### Memorandum

Subject: Review of Newark Bay Study Area Screening Level Ecological Risk Assessment (SLERA)

**Date:** June 14, 2010

**FIGURE** 1

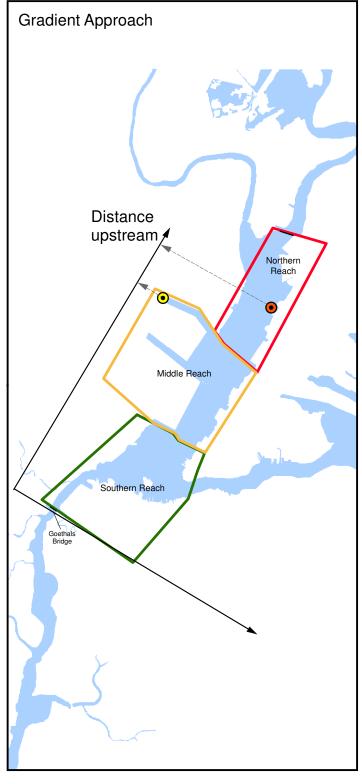
The SLERA uses an inappropriate coordinate system, which has led to assignment of sampling locations to incorrect "Reaches" within Newark Bay and generation of inaccurate concentration-distance plots. The coordinate system used in the SLERA measures distance along an arbitrary north-south axis rather than along the axis of flow within the Bay (Figure 1). This seemingly small difference in axis orientation has a significant effect on data interpretation (Figure 1). For example, as illustrated in Figure 1, samples collected from Port Newark Channel and portions of the Northern Reach appear at the same location in the concentration-distance plots presented in the SLERA (Figures 8-15 of the SLERA). Consequently, concentrations measured in samples collected in the Northern Reach are being interpreted

as having been collected in the Middle Reach and/or Port Newark Channel. This problem with the coordinate system appears to have led to assigning sampling location NB901 (discussed below) to the Middle Reach in the SLERA. We recommend that the coordinate system misalignment be rectified and the assignment of samples to Newark Bay Reaches be reviewed by US EPA, prior to commencement of the BERA.
